# UNITED STATES PATENT AND TRADEMARK OFFICE

10/591,320

<b>Office Action Summary</b>	<b>Application No.</b> 10/591,320	<b>Applicant(s)</b> TSUBOI ET AL.	
	<b>Examiner</b> RYAN DODD	<b>Art Unit</b> 3655

## **DETAILED ACTION**

**Fig. 1**

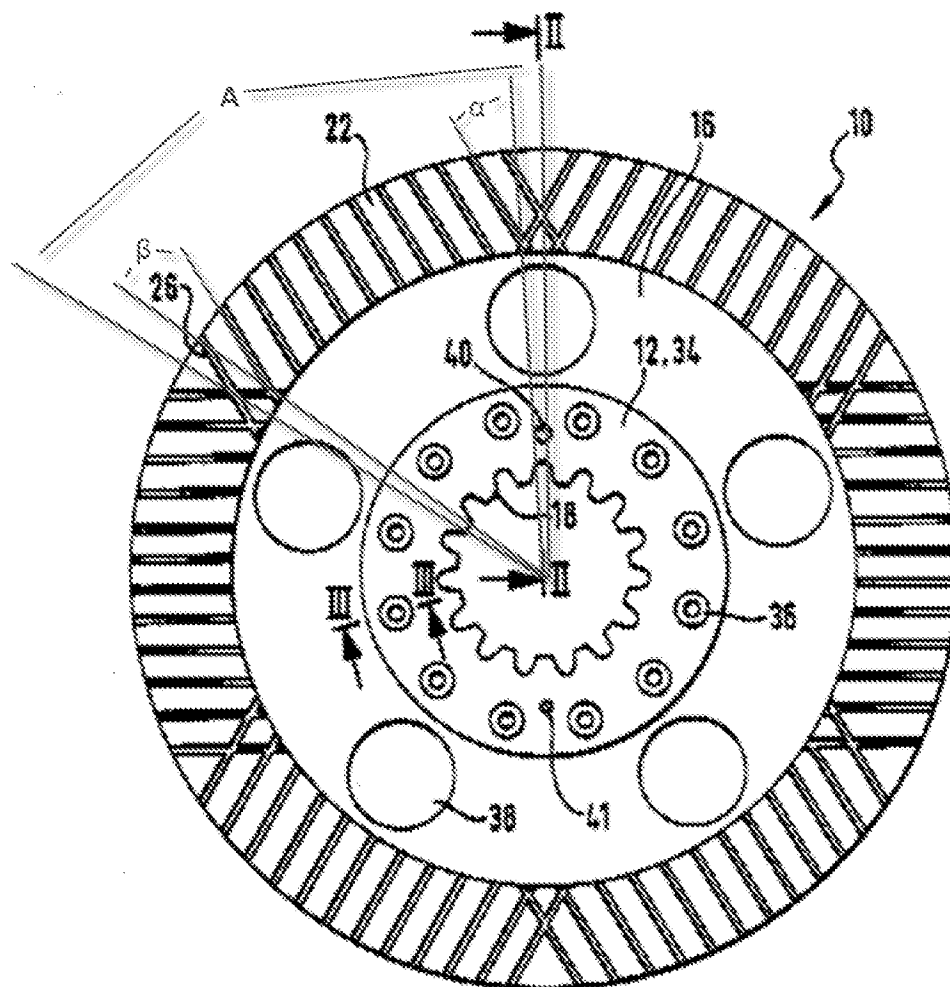
Claims 1 and 2, as best understood, are rejected under 35 U.S.C. 102(b) as being anticipated by Voegelé 4967893 (henceforth Voegelé '893). Voegelé '893 discloses a wet clutch friction plate comprising a core plate (support plate) and a friction material (friction lining 22) bonded to a side face of the core plate, a plurality of oil channels (grooves 26) being formed in the friction material so as to provide communication

between inner and outer peripheral edges of the friction material (21), characterized in that a plurality of oil channels having a discharge angle ( $\beta$ ) that discharge oil from an inner peripheral side to an outer peripheral side of the friction plate (15) when the friction plate rotates and a plurality of oil channels having an inflow angle ( $\alpha$ ) that draw oil in from the outer peripheral side to the inner peripheral side of the friction plate (15) are mixed at substantially equal intervals (See figure below).

Vogele '893 likewise discloses that the friction plate is divided into a plurality of regions (A) arranged in the peripheral direction, a plurality of oil channels parallel to each other are formed in the friction material of each region (A), and one oil channel

and another oil channel (22) that are positioned at opposite end parts in the peripheral direction of each region (A) are given the discharge angle ( $\beta$ ) and the inflow angle ( $\alpha$ ) respectively.
